From: Scala, Mary Joy
Sent: Thursday, September 18, 2014 11:04 AM
To: 'Knipp, Jay'
Cc: 'mrmstynson@gmail.com'
Subject: BAR Action - September 16, 2014 - 427 Park Street

Certificate of Appropriateness Application (deferred from August)

BAR 14-08-03
427 Park Street
Tax Parcel 530023000
Price-Poore House, LLC, Owner/ Jay Knipp, Ilex Construction, Applicant
Partial demolition, new rear addition, parking lot

**CITY OF CHARLOTTESVILLE
BOARD OF ARCHITECTURAL REVIEW
STAFF REPORT
September 16, 2014 (deferred from August)**

PROJECT: 427 PARK STREET SITE PLAN AMENDMENT
 SHEET: SITE PLAN

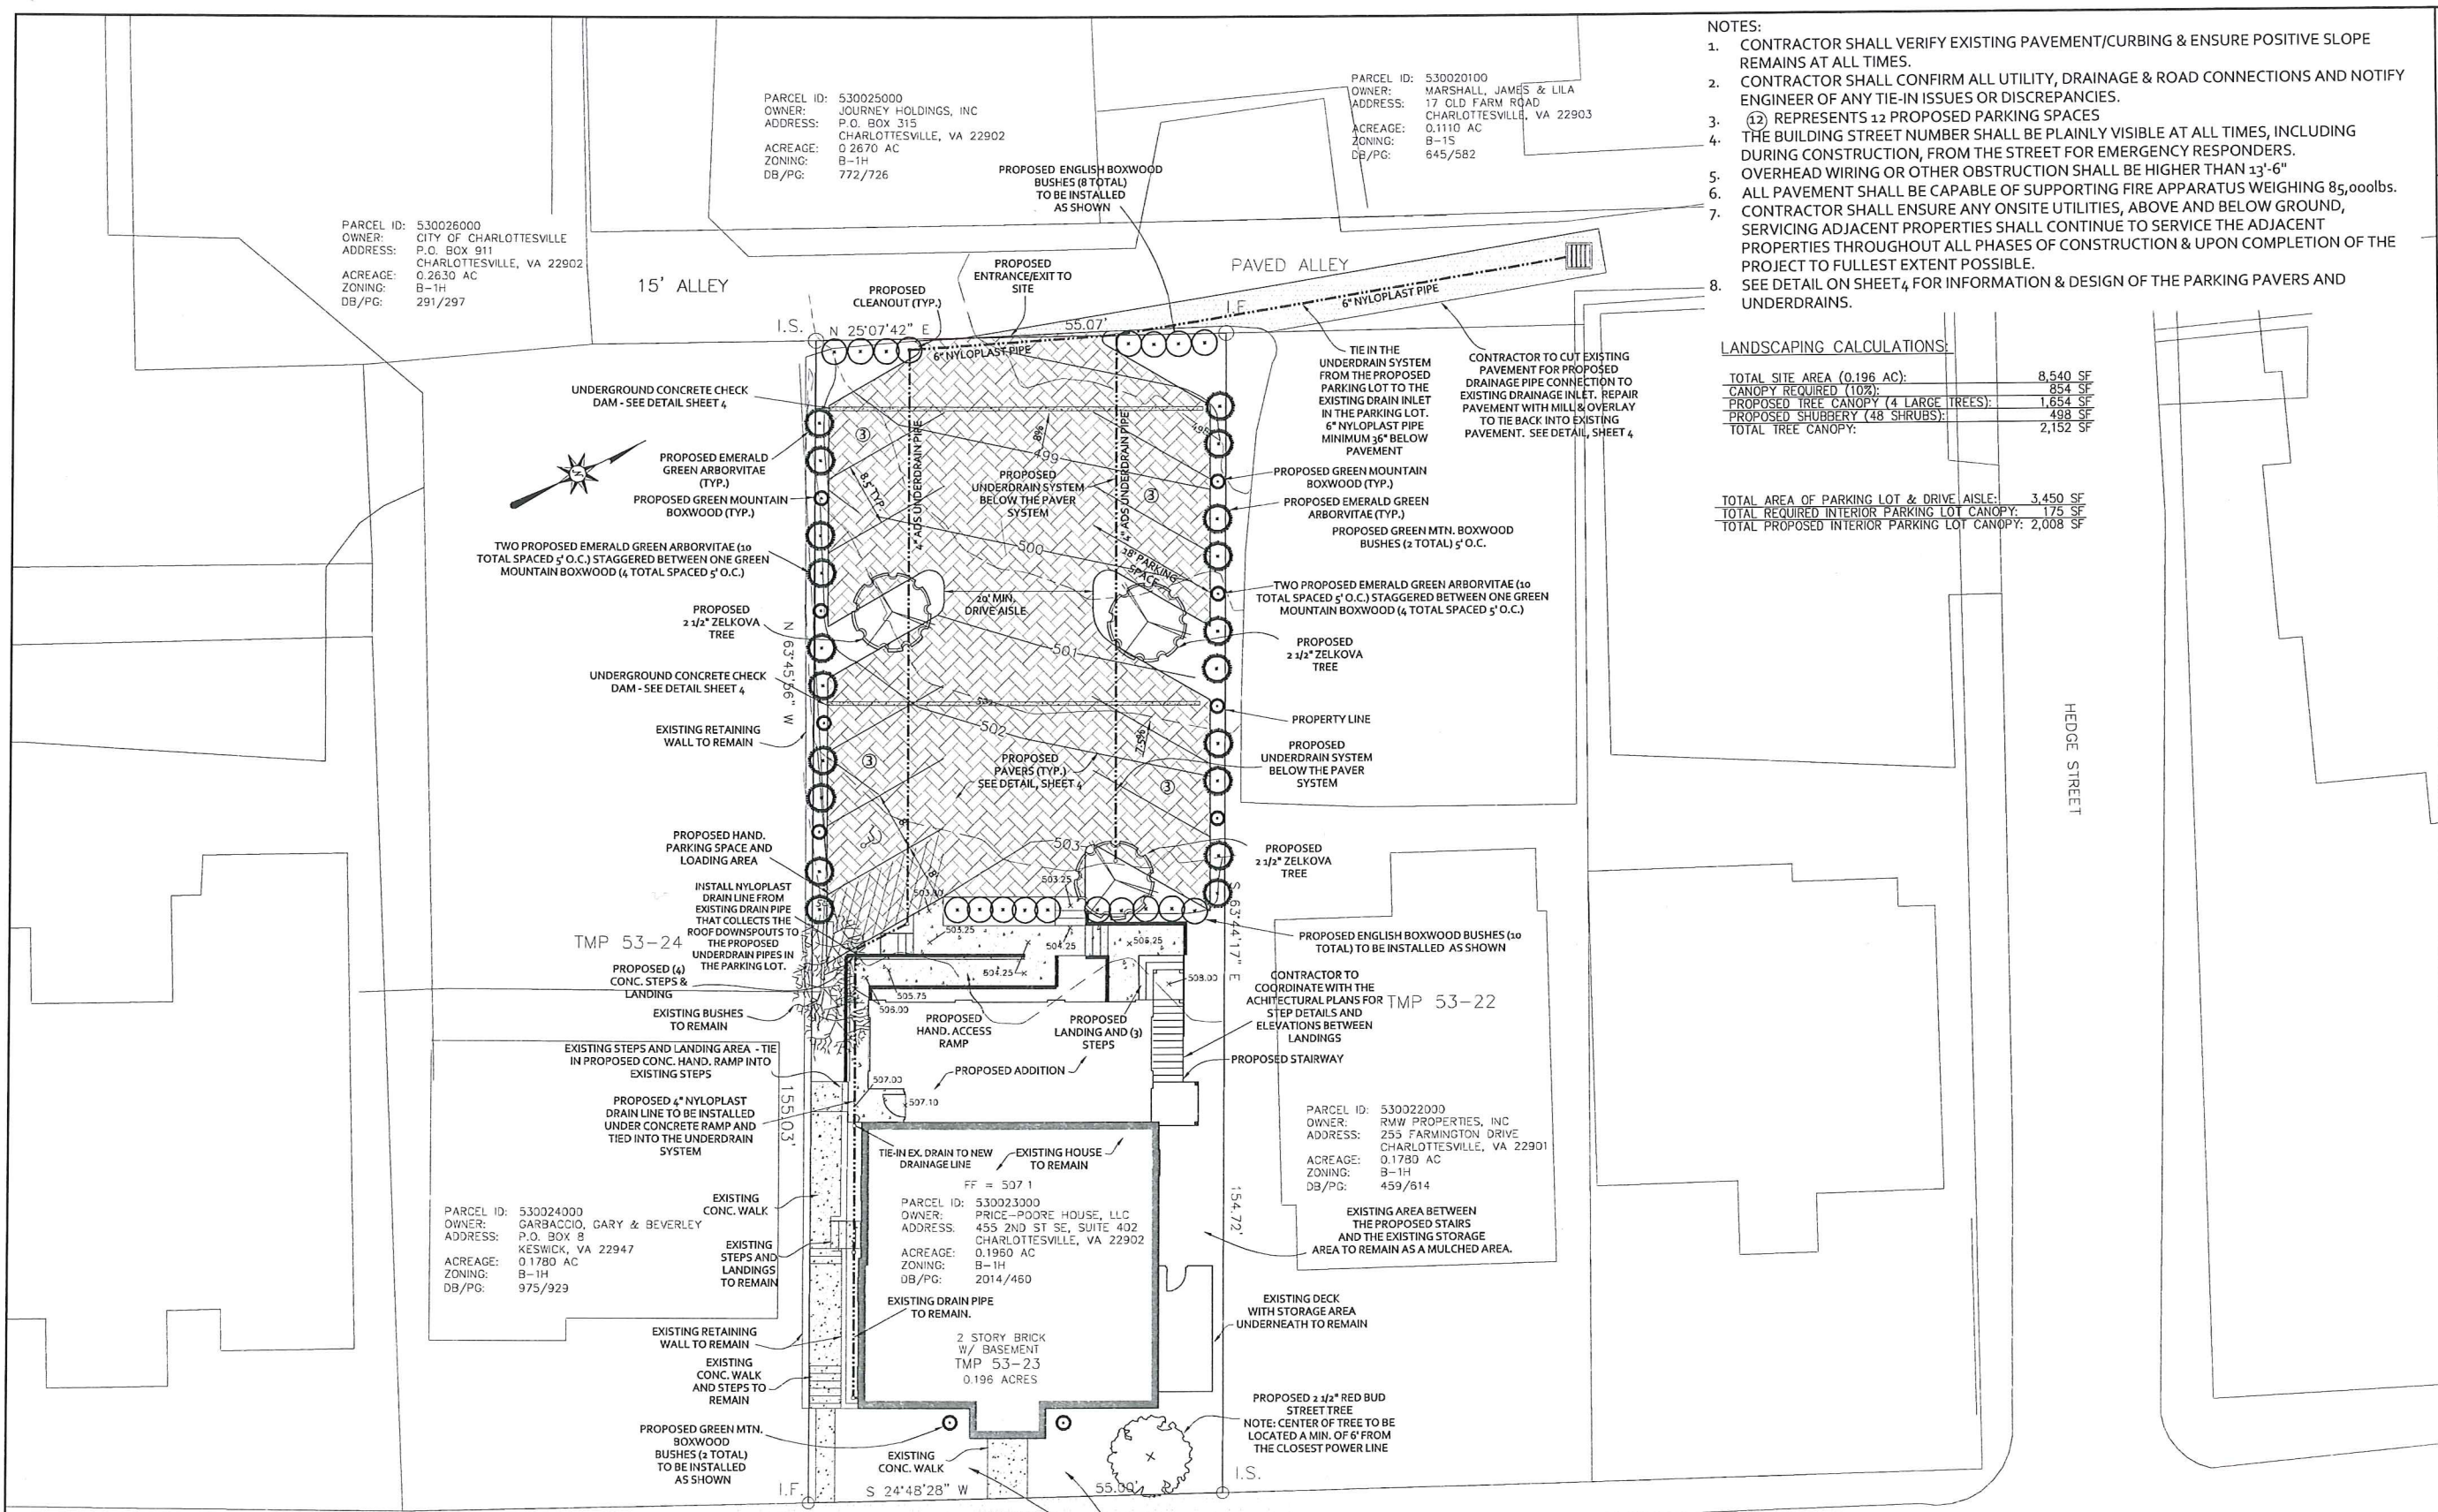
Regarding the landscape plan, the BAR strongly recommended reconsideration of (single trunk) trees instead of shrubs at bottom of lot; possibly make tree space larger on south side and delete tree space on north side of lot to make room for larger, native species tree instead of Zelcova; make groupings of shrubs along sides more narrow (possibly pencil hollies instead of arborvitae), and closer-spaced with larger spaces between groupings.

The parking lot requires a site plan review in addition to BAR review. The BAR should comment on the proposed new parking and landscaping plan.

Please submit a revised parking and landscape plan to me for review and approval before your site plan is approved.
